Our Case Number: ABP-318446-23

Re: Proposed construction of Coumnagappul Wind Farm consisting of 10 no. turbines and associated infrastructure.

An Bord Pleanála Case reference: PA93.318446

Observation relating to : Proposed construction of Coumnagappul Wind Farm consisting of 10 no. turbines and associated infrastructure in the townlands of Coumnagappul, Carrigbrack, Knockavanniamountain, Barricreemountain Upper and Glennaneanemountain, Skeehans, Lagg, Co. Waterford.

COLUMMAGAPUL WINDFARM EIR

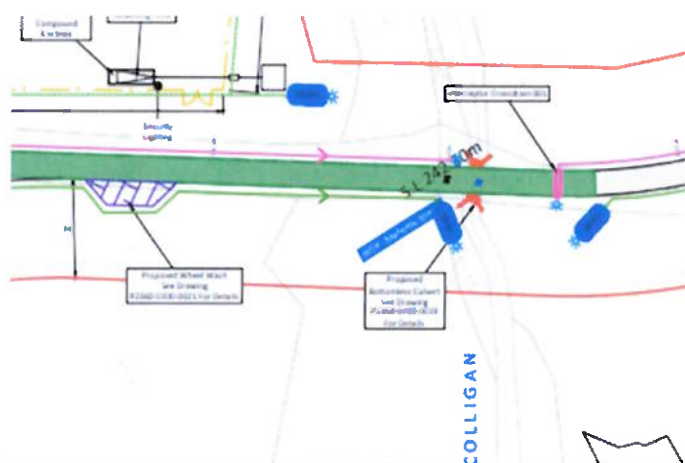
Above it mentions that this distance from construction works to the Colligan River is 0.08km however

“Here the access road between turbines T08 and T12 crosses over the Colligan River, requiring a bridge structure and approach earthworks.” (Chapter 11 – Soils, Geology and Hydrogeology pg 10 of 69).

The applicant failed to mention that there will be construction works **passing over** the Colligan River in the SAC section of the application. Another instance of the Applicant attempting to make light of the construction works that will be done on top of the rivers and streams in this area.

Table 3-1: European Sites Within the Potential ZOI

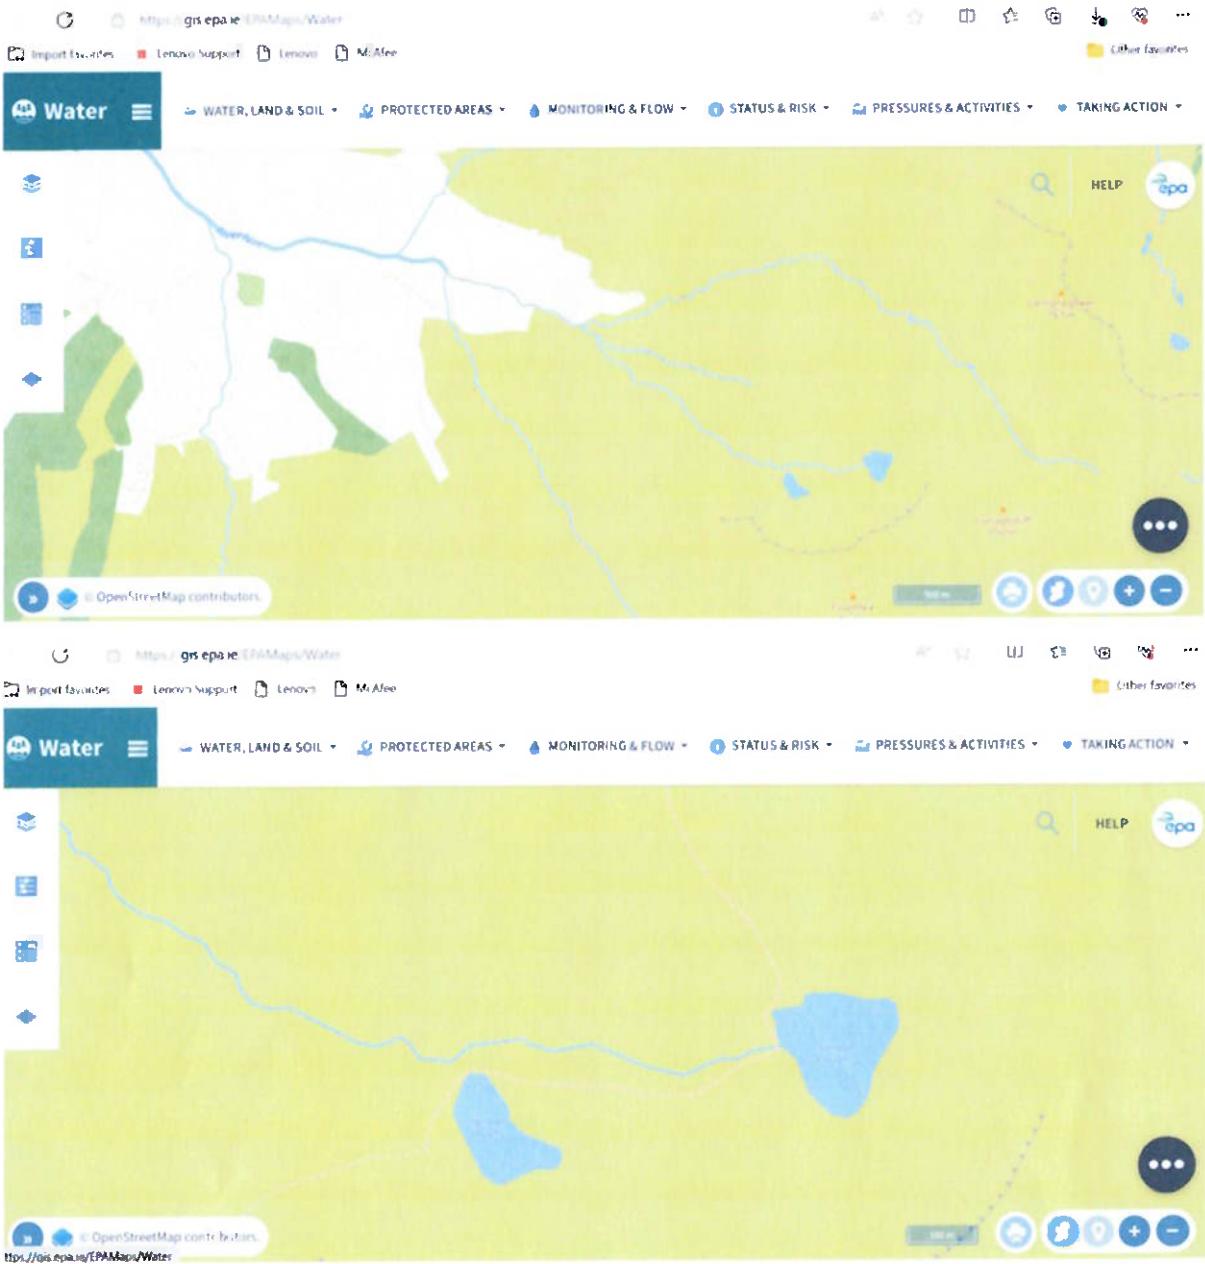
In reference to the above mentioned Appropriate Assessment, the Comeragh Mountains SAC was not considered by the Applicant for further screening.

As can be seen above the Applicant states there is “no hydrological connectivity between the Site and the SAC”.

This is untrue. The River Nire flows from Sgilloge Lough in the Comeragh Mountains, see map below.

The images below are taken from the Waterford City and County Development Plan 2022-2028, Landscape and Seascape Character Assessment Map.

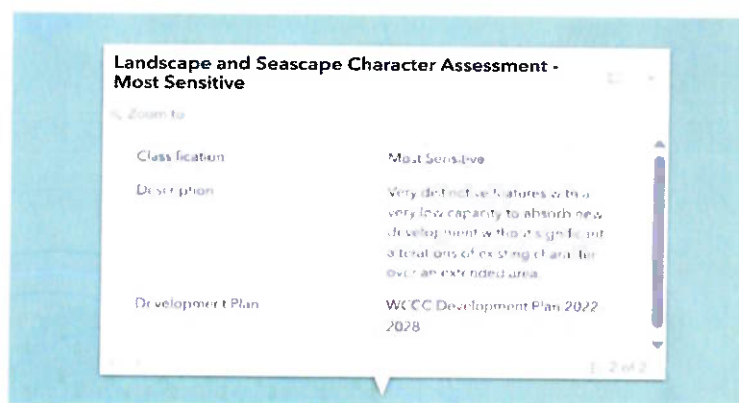
The blue arrow points to the spot the above photograph was taken by the Applicant. It can clearly be seen on the map that this is the Mauma/Maum Road.

This area is a scenic route, protected view and is “most sensitive” to new development. It most certainly not just a “*local road at Bohadoon*”.
